ADDENDUM NO. 02

PROJECT NAME: Hemisfair Internal Street Improvements: Water and E. Nueva

DATE: October 8, 2014

TCI PROJECT NO.: **40-00421**

SCALE: 1"=50'		SHEET 1 OF 2	
DSN: JMG	CK: SDT	DATE	JOB NO.
DRN: KRK	CK: -	SEPT. 2014	218609
			SHEET NO. 113

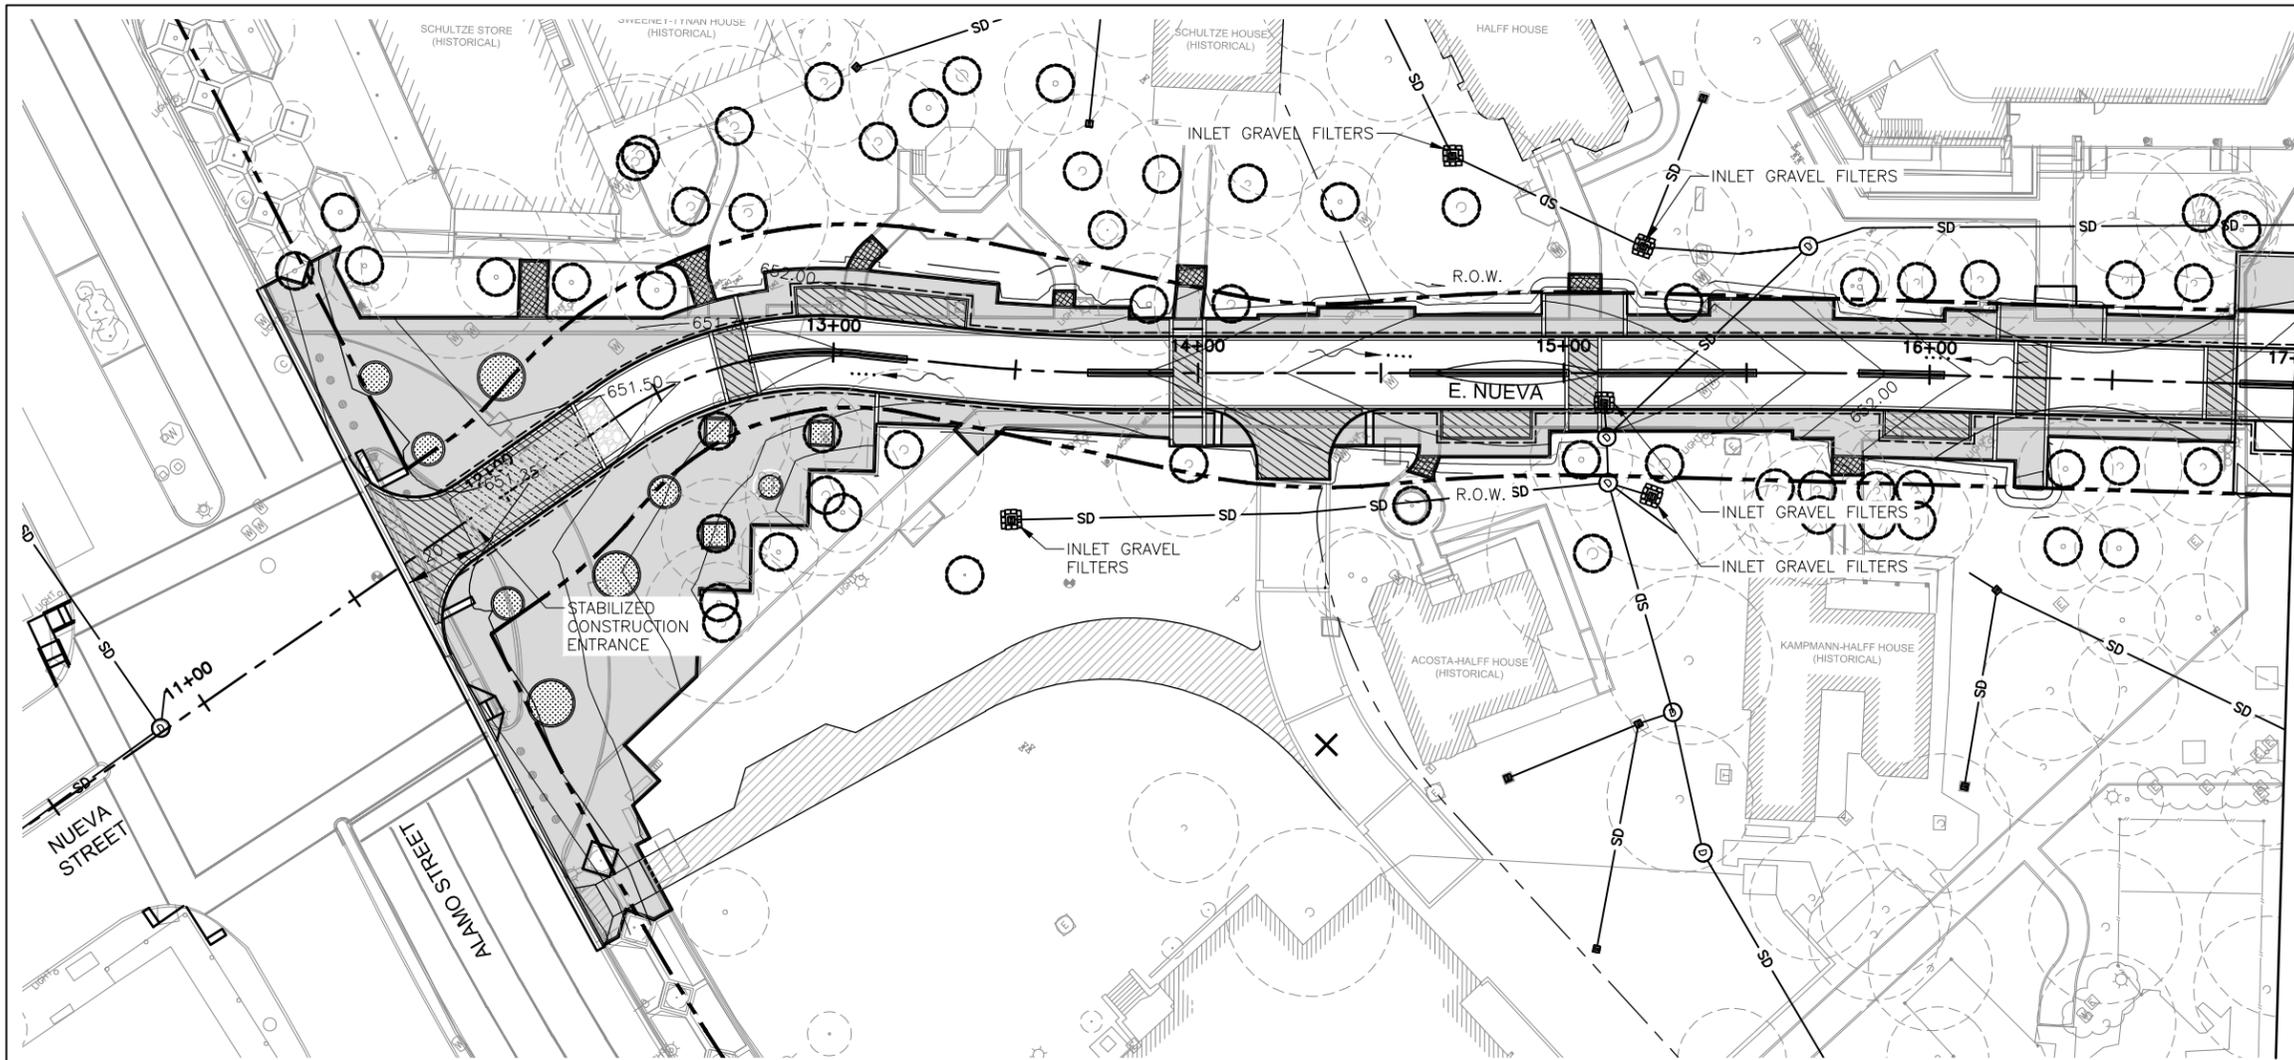
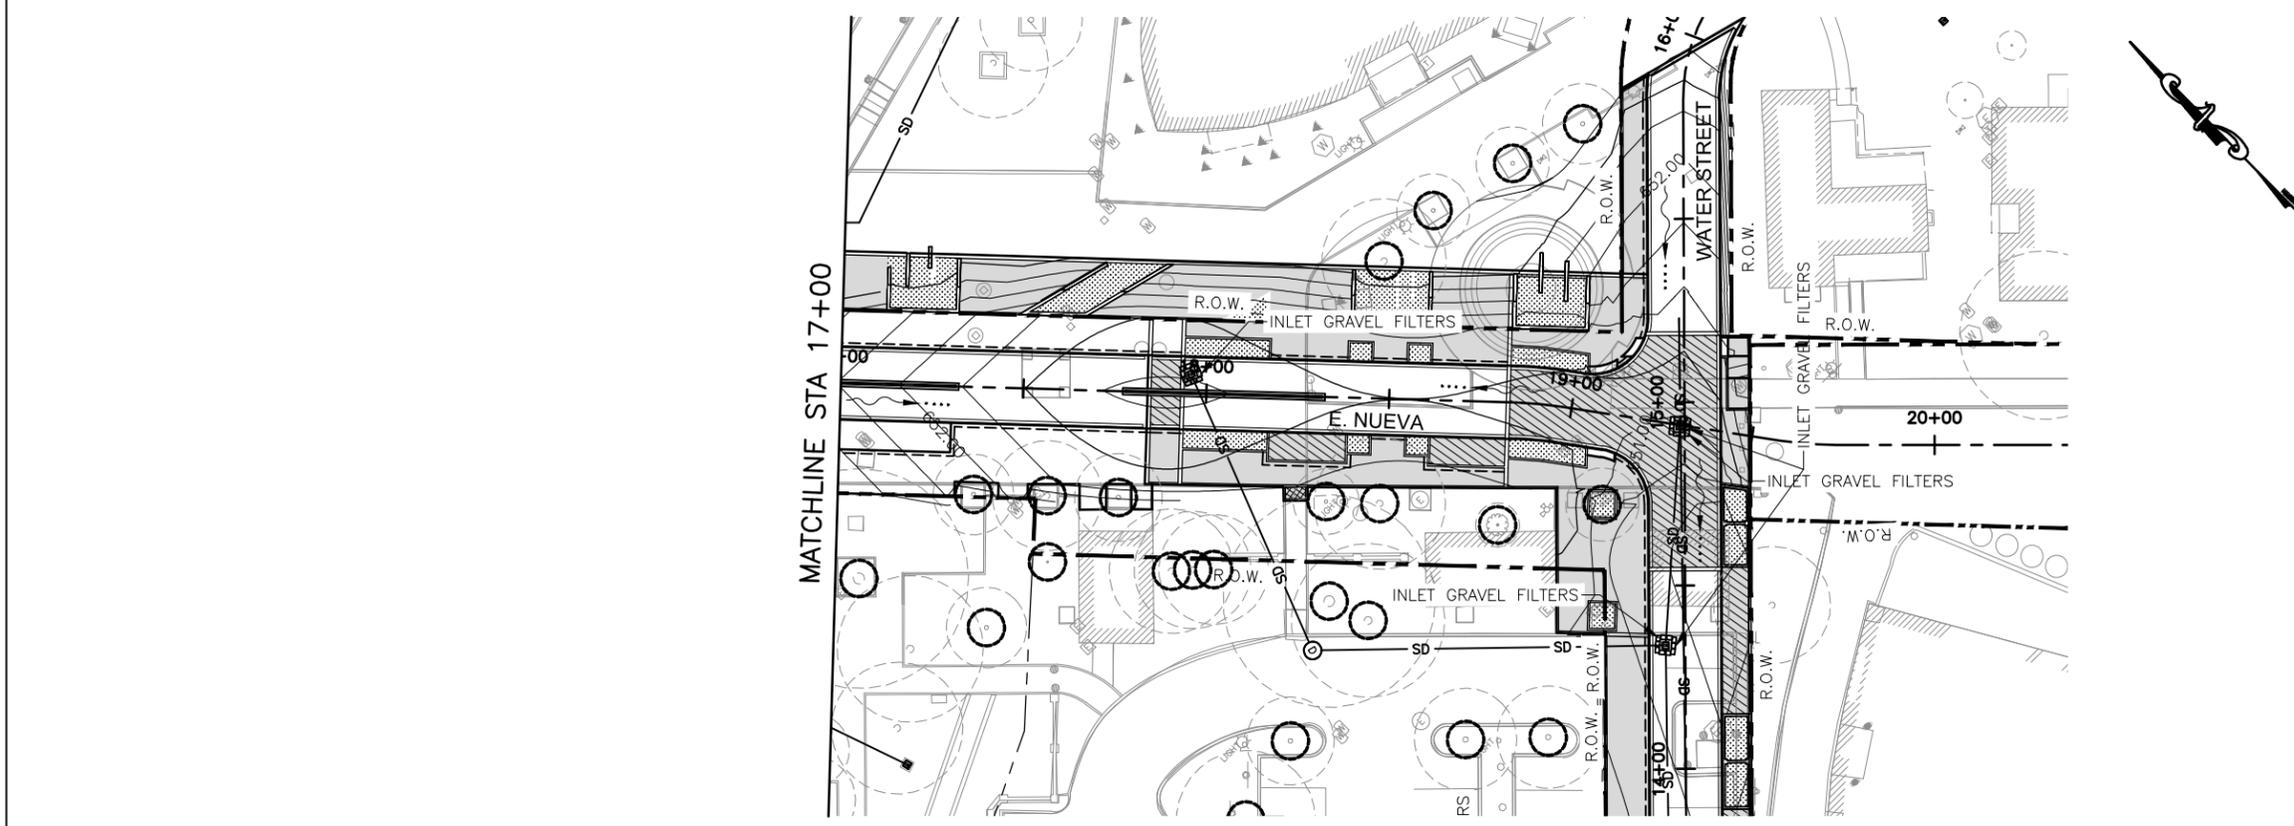
- Sheets 113-114 – SW3P: Updated roadway hatching
- Sheet 117 – Small Sign Plan: Updated roadway hatching
- "L" sheets are amended to include sheet L1-8 (no change to bid items or quantities)

DSN: AM	CK: ---	DATE	JOB NO.	SHEET NO.
DRN: AM	CK: ---	SEPT. 2014		L2-3

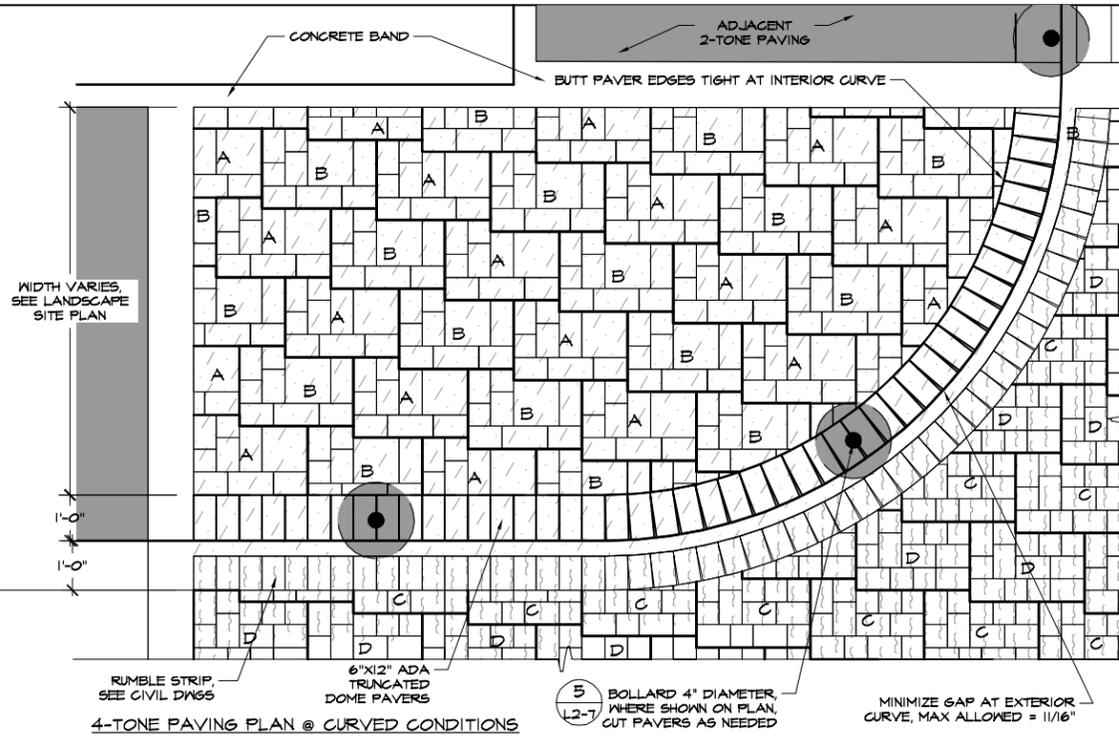
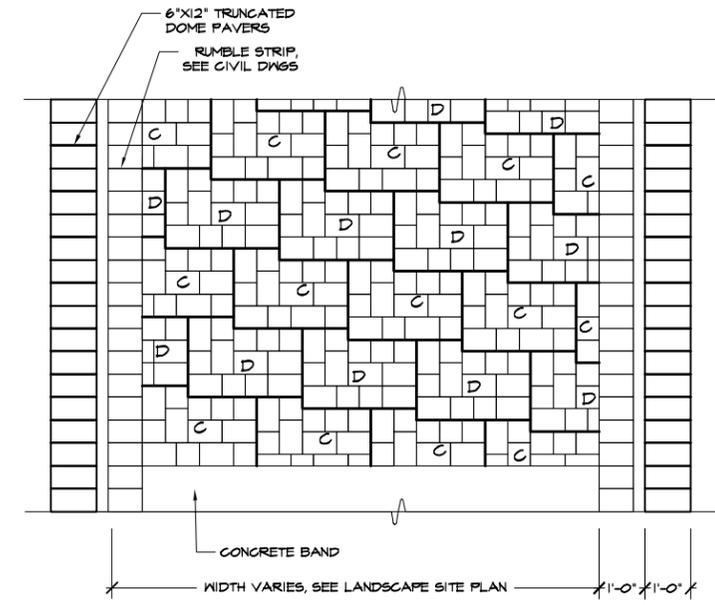
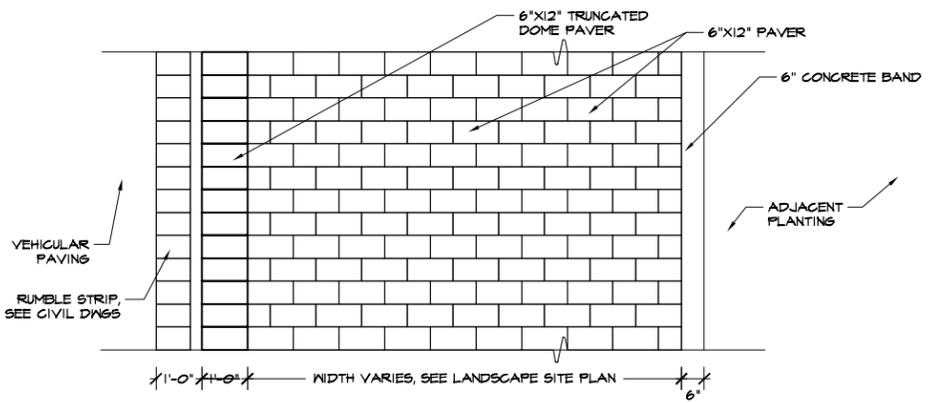
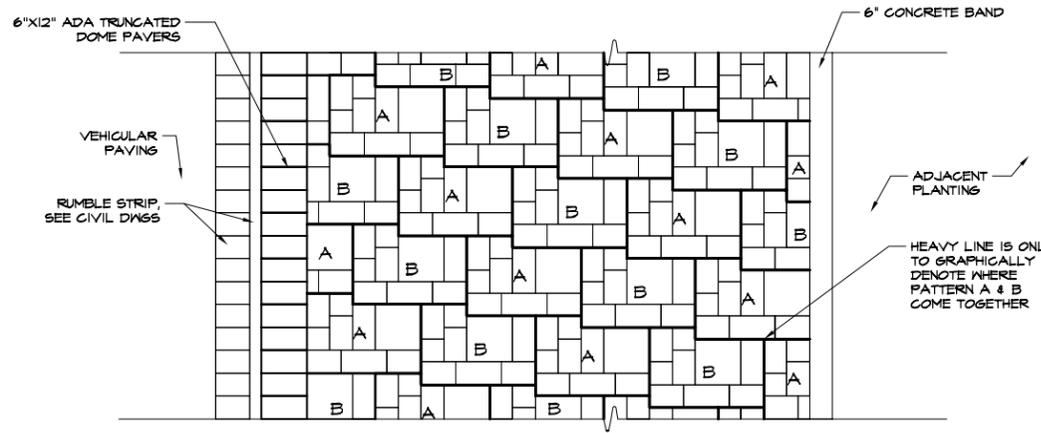
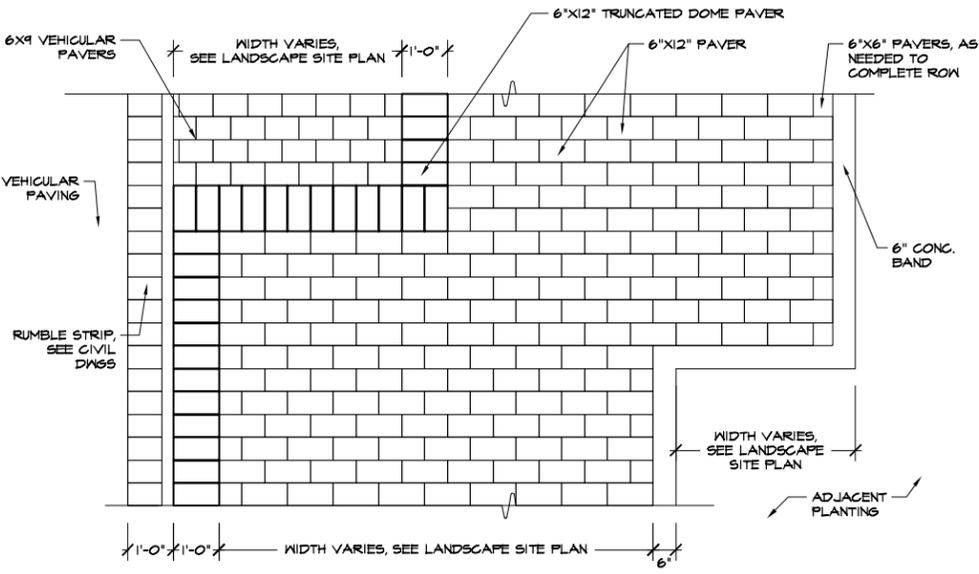
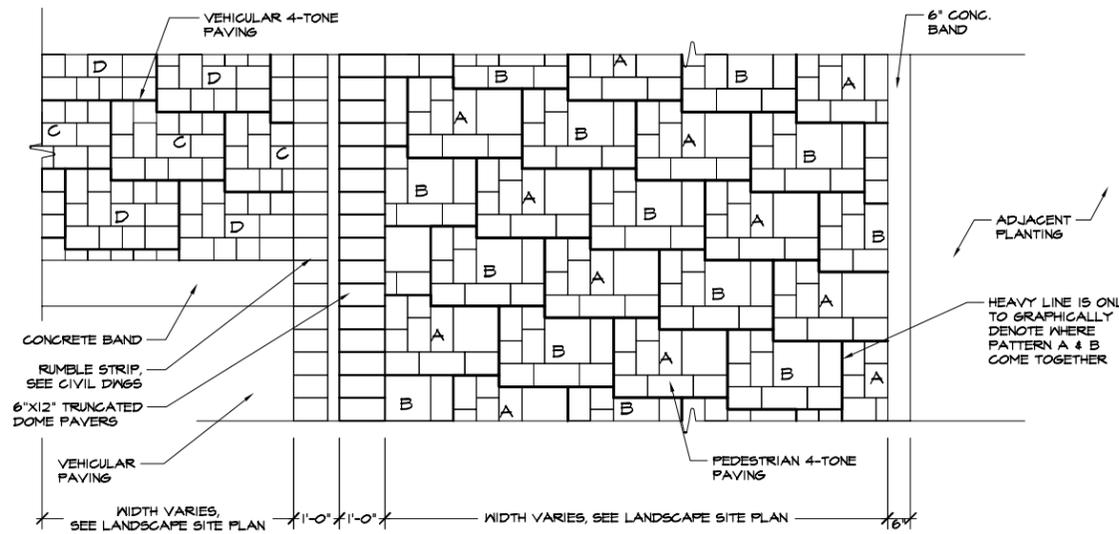
- Sheet L2-3, is modified as follows:
 - Detail 2 is modified to delete 6x12 and 12x12 pavers from 4-tone pattern in vehicular areas, replacing them with 6x6 and 6x9 pavers;

- Detail 2 is modified to delete 6x12 pavers from the 2-tone vehicular paving areas and replace them with 6x9 pavers
 - Detail 1 is deleted from this sheet and added to sheet L2-5

2 CONCRETE JOINTS Scale: 3/4" = 1'-0"

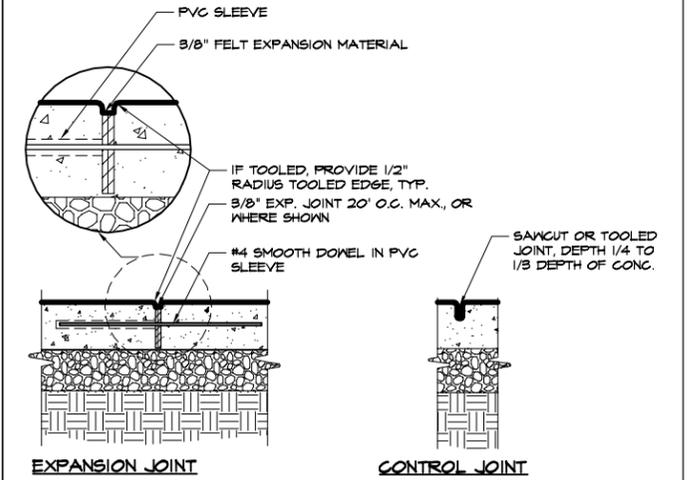
- Sheet L2-4, expansion and control joint reference keys modified to refer to detail 2, sheet L2-5
- Sheet L2-5, detail 2, Concrete Joints added.
